Liberty School District – LED Lighting Upgrades
Addendum No: 001
Description Narrative
September 5, 2023

**Liberty North High School Lighting Upgrades
Smith & Boucher Project No. 2314711**

**Liberty Discovery Middle School Lighting Upgrades
Smith & Boucher Project No. 2314702**

E102A

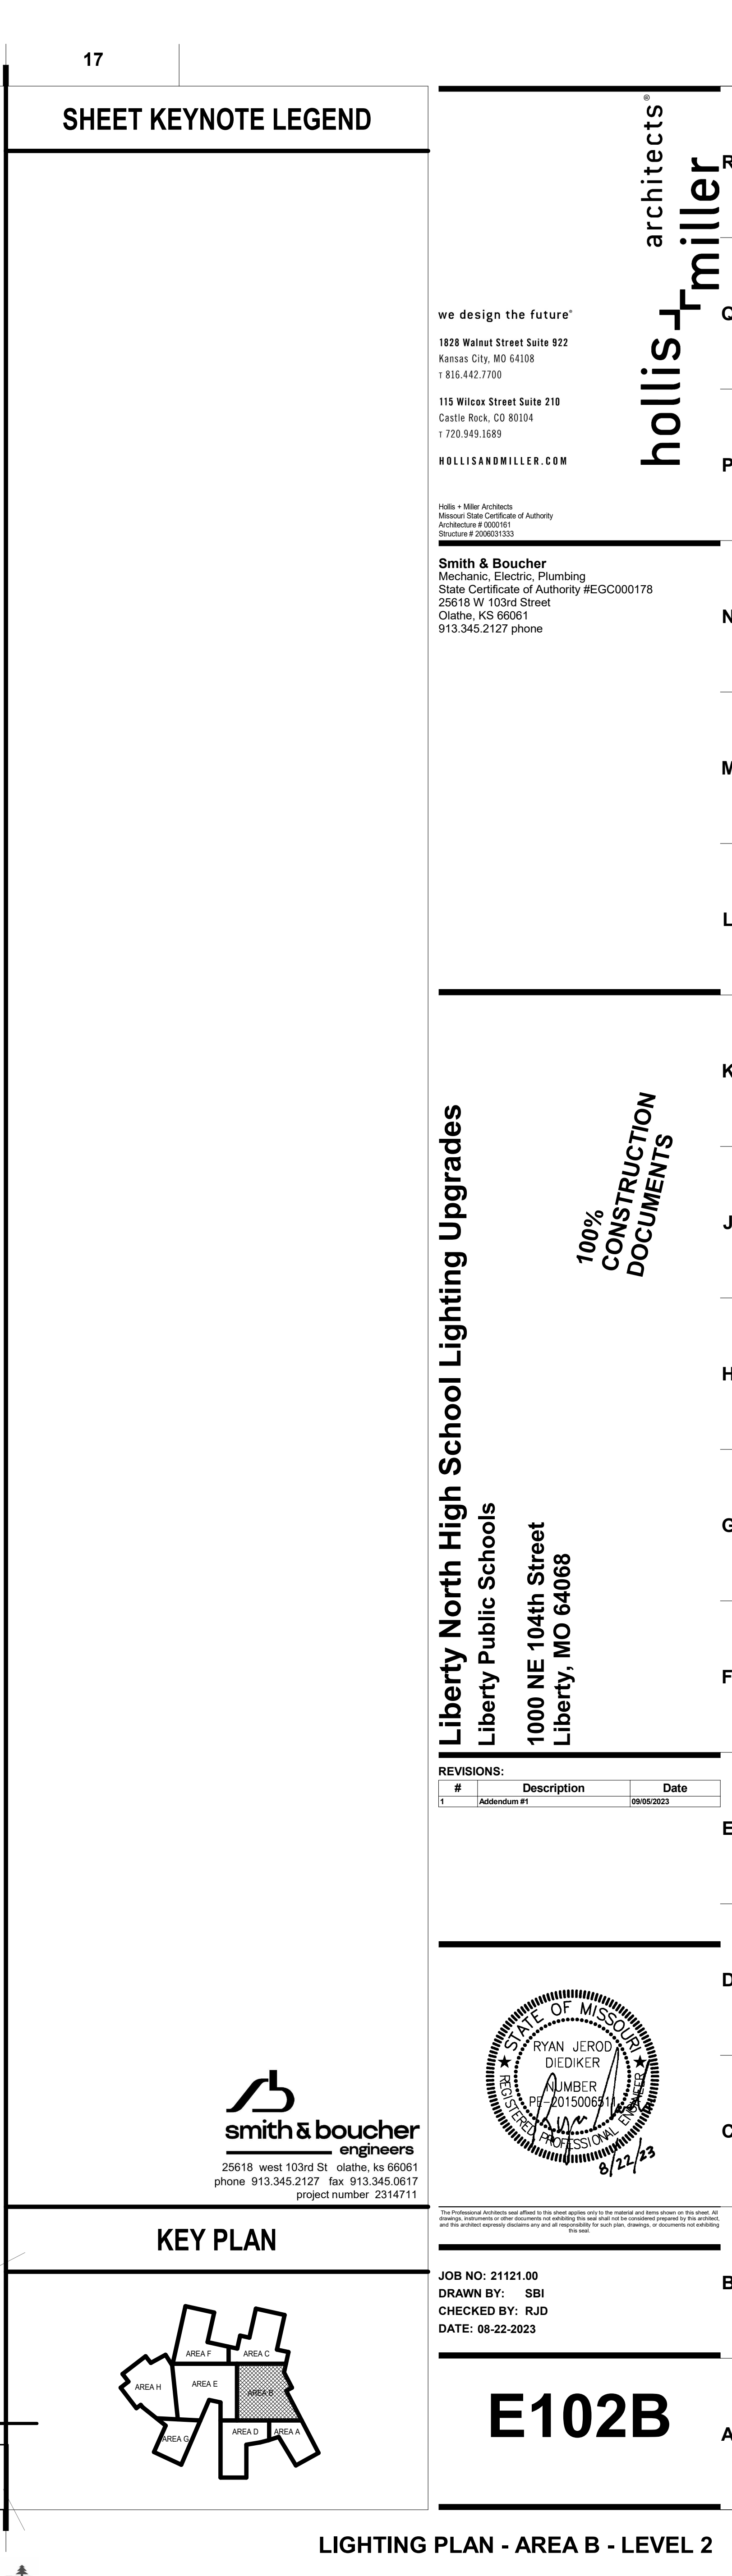
10. Sheet E102A-UPPER LEVEL – AREA A
 - a. Revised corridor troffers and troffers in small rooms to be RA-L indicating that the flat panel troffer to be set on the lowest output level.

- b. Added in missing troffers in corridors.
 - c. Added in hatch for clarify of area with existing LED troffers.

E102D

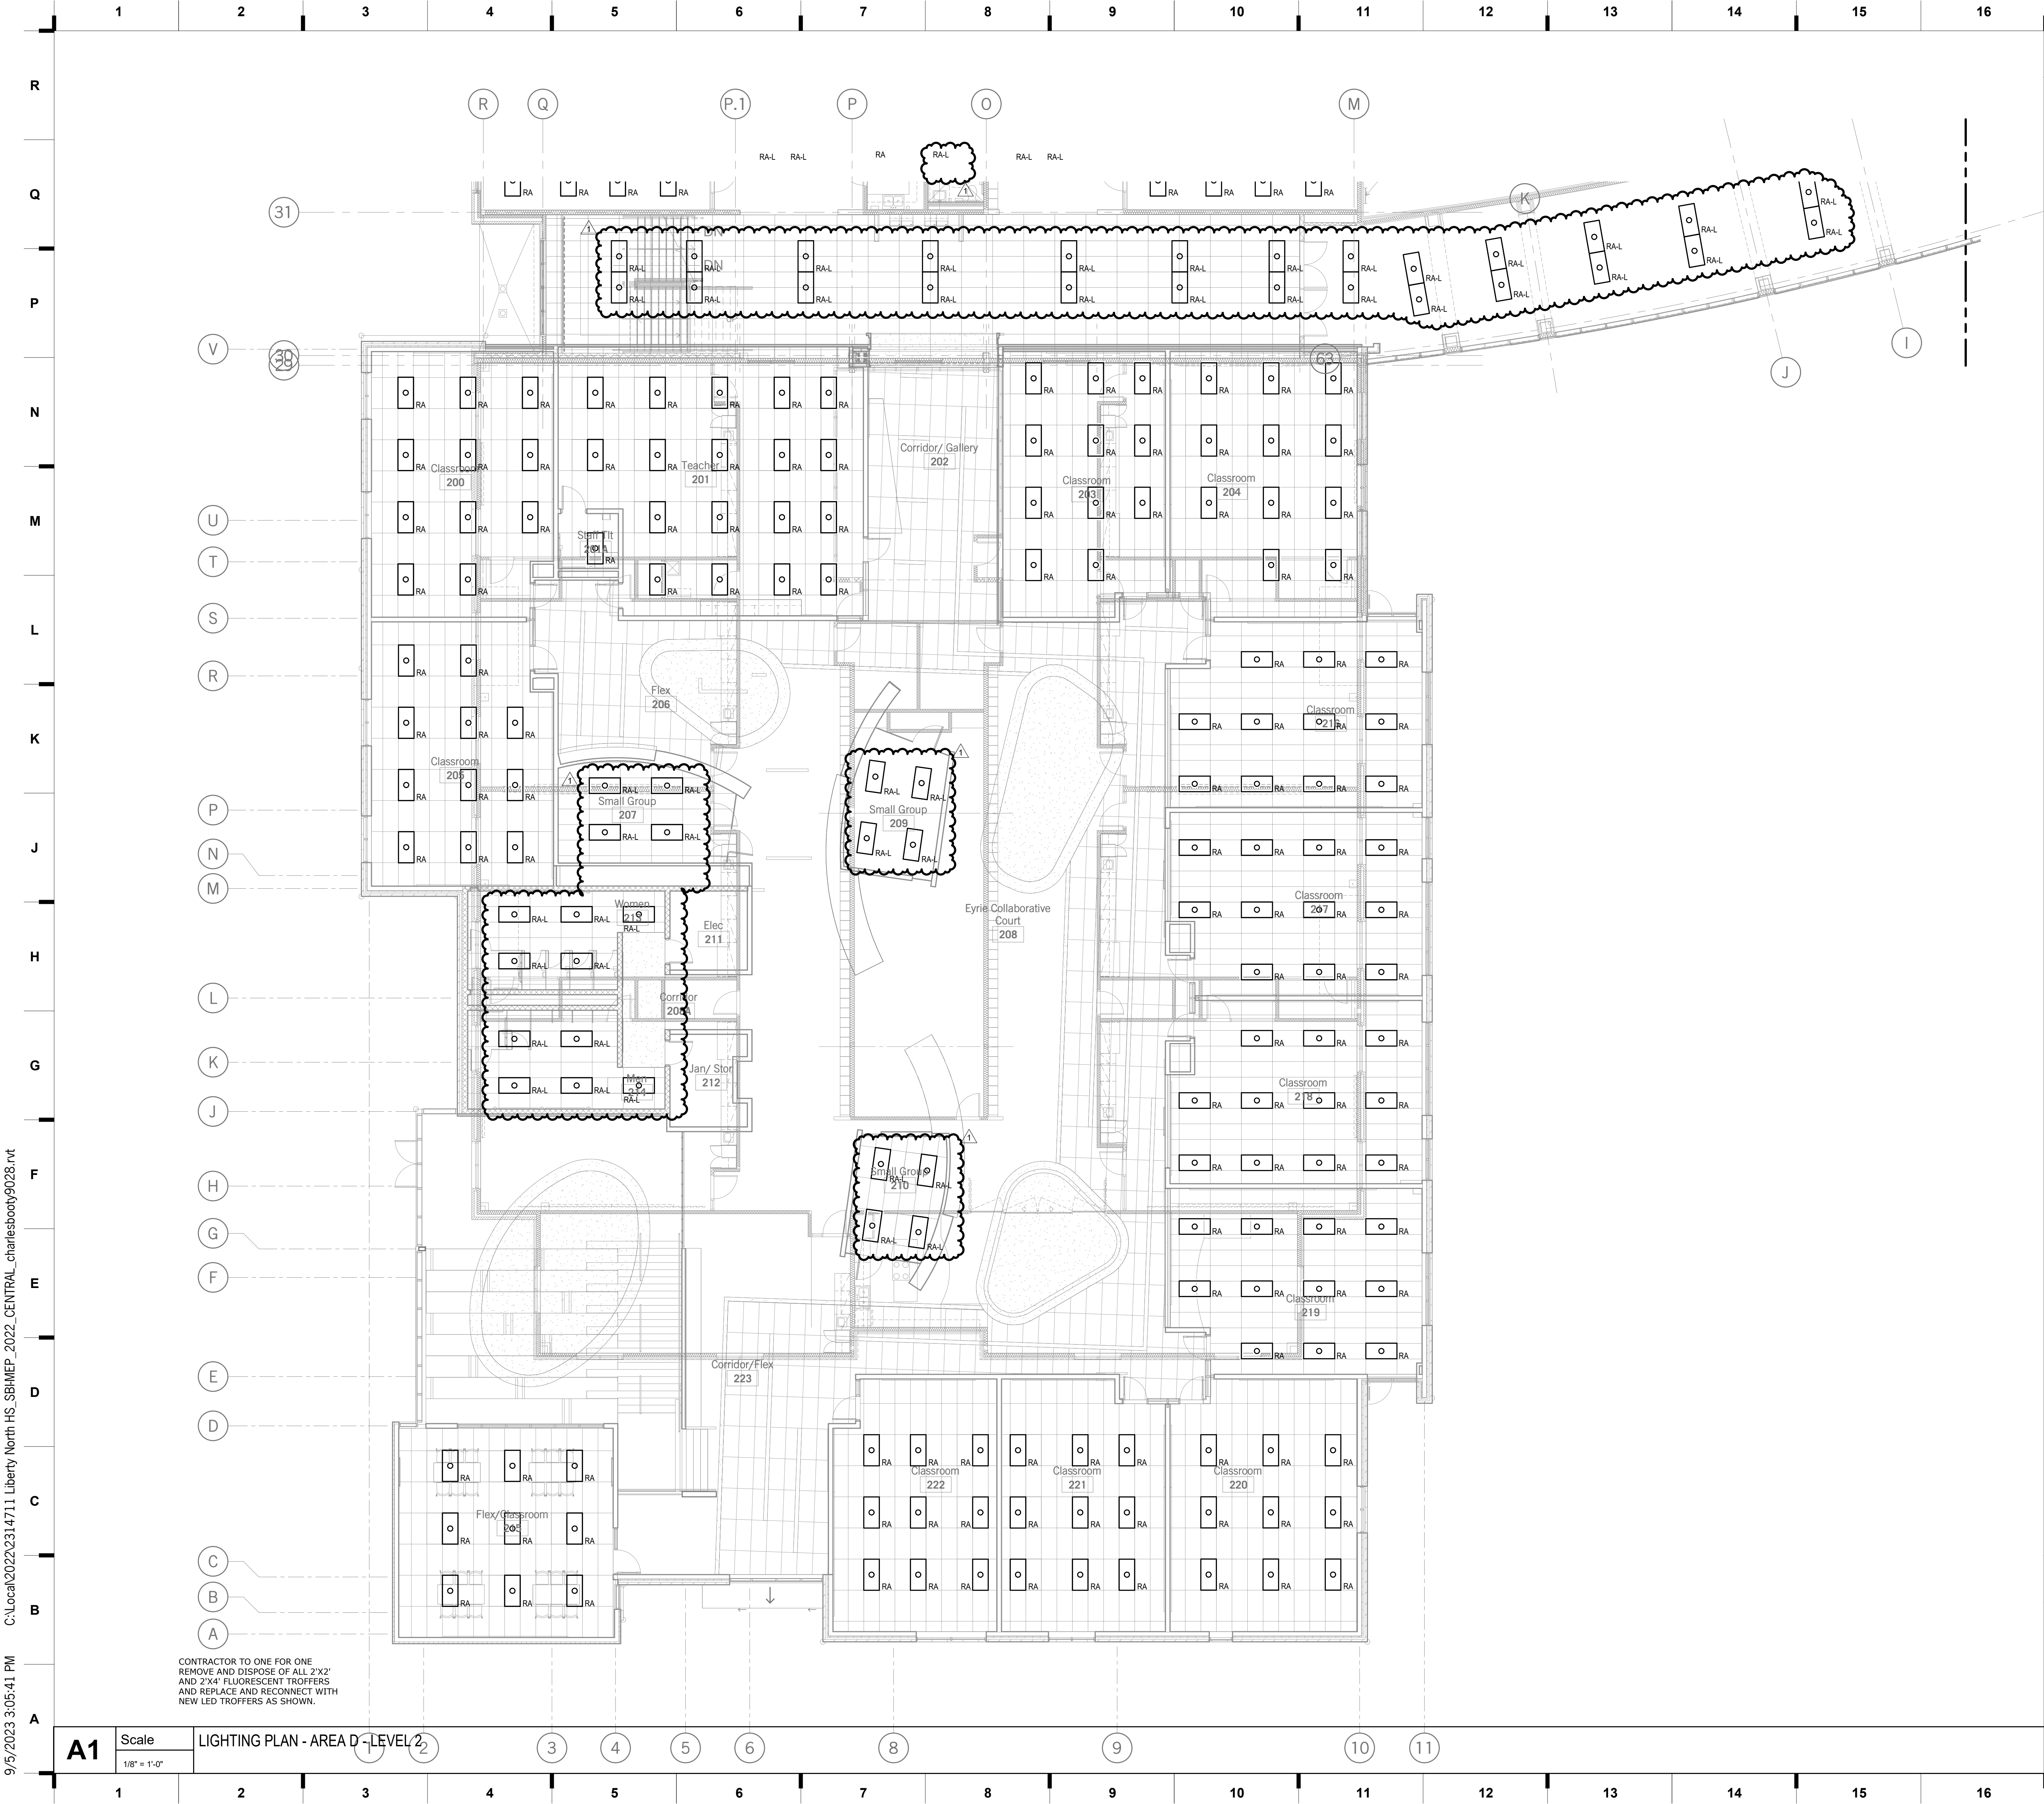
11. Sheet E102B-UPPER LEVEL – AREA B
 - a. Revised corridor troffers and troffers in small rooms to be RA-L indicating that the flat panel troffer to be set on the lowest output level.
 - b. Added in missing troffers in corridor/upper lobby area and storage room.
12. Sheet E102D-UPPER LEVEL – AREA D
 - a. Revised corridor troffers and troffers in small rooms to be RA-L indicating that the flat panel troffer to be set on the lowest output level.
13. Sheet E102E-UPPER LEVEL – AREA E
 - a. Revised corridor troffers and troffers in small rooms to be RA-L indicating that the flat panel troffer to be set on the lowest output level.
- ~~14. Sheet E102H-UPPER LEVEL – AREA H~~
 - a. Sheet removed from plans since area does not exist.
15. Sheet E301-Schedules
 - a. Added Signify to approved manufactures.
